REVISED EXPRESS TERMS  
FOR  
PROPOSED BUILDING STANDARDS  
OF THE  
DEPARTMENT OF HOUSING AND COMMUNITY DEVELOPMENT  
REGARDING THE 2013 CALIFORNIA BUILDING CODE  
CALIFORNIA CODE OF REGULATIONS, TITLE 24, PART 2, CHAPTER 11A  
“HOUSING ACCESSIBILITY”  
(HCD 04/13)

The Department of Housing and Community Development (HCD) proposes to make necessary changes to the 2013 California Building Code, Chapter 11A – Housing Accessibility, as presented on the following pages.

FIGURE 11A-7A  
MINIMUM DIMENSIONS OF ELEVATOR CARS

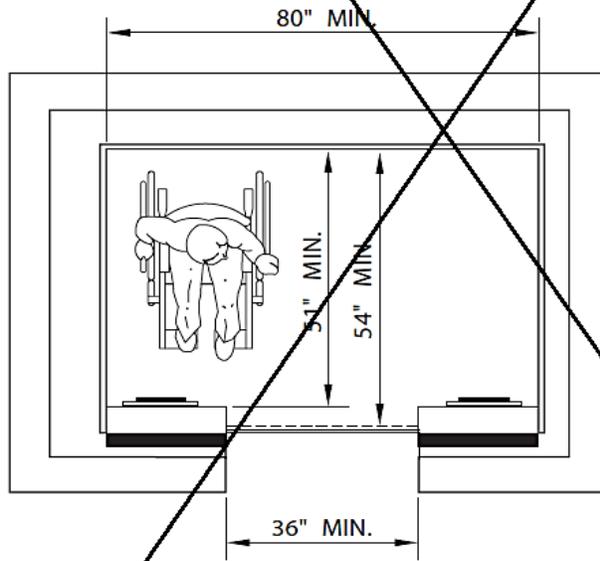
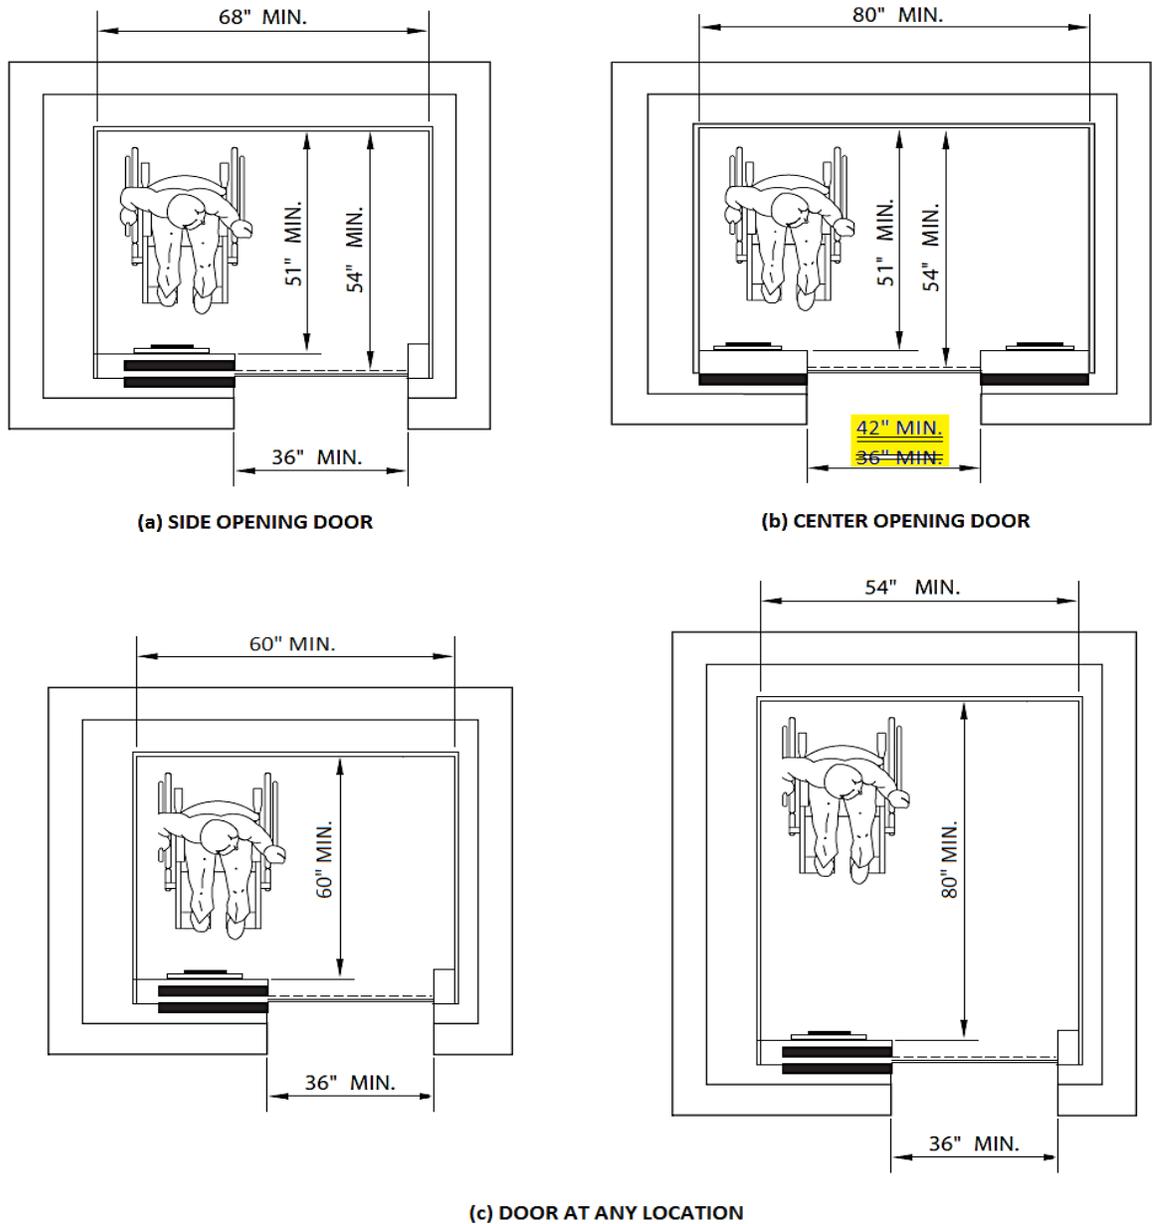
HCD initially proposed to amend Figure 11A-7A to align with all proposed modifications to Section 1124A. However, after review, HCD discovered that the clear width of a center opening door is incorrect (36 inches on the figure; 42 inches in the text of Section 1124A). HCD proposes to change the dimension and correct the oversight.

**FIGURE 11A-7C  
 HOISTWAY AND ELEVATOR ENTRANCES**

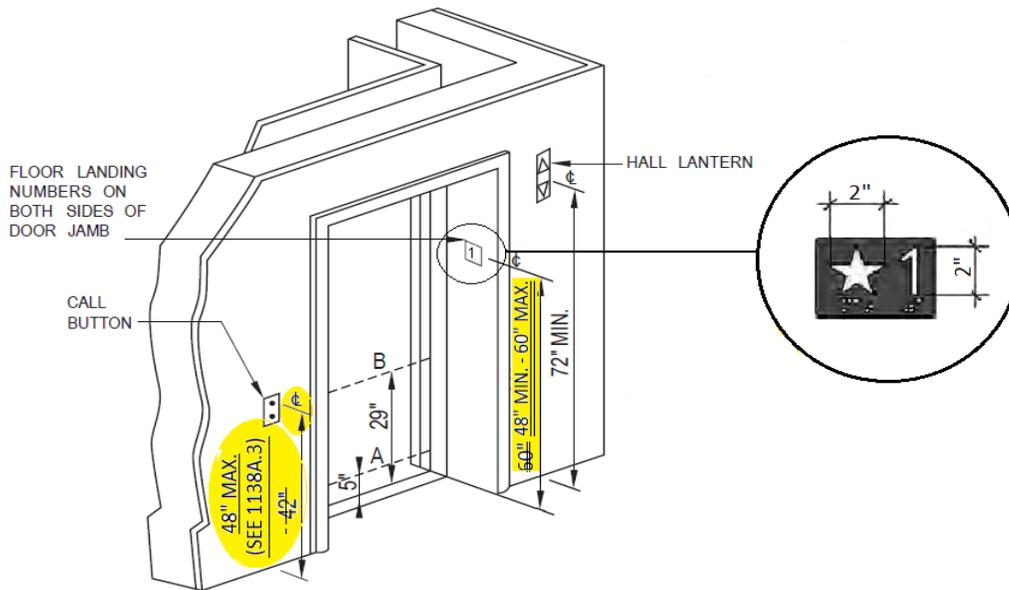
HCD initially proposed to amend Figure 11A-7C to align with all proposed modifications to Section 1124A. However, after review, HCD discovered that the modified figure proposed for the 45-day public comment period did not contain all details related to the doorjamb marking as intended. HCD proposes to correct the oversight, adding the minimum and maximum dimensions for doorjamb marking height, as proposed in Section 1124A.
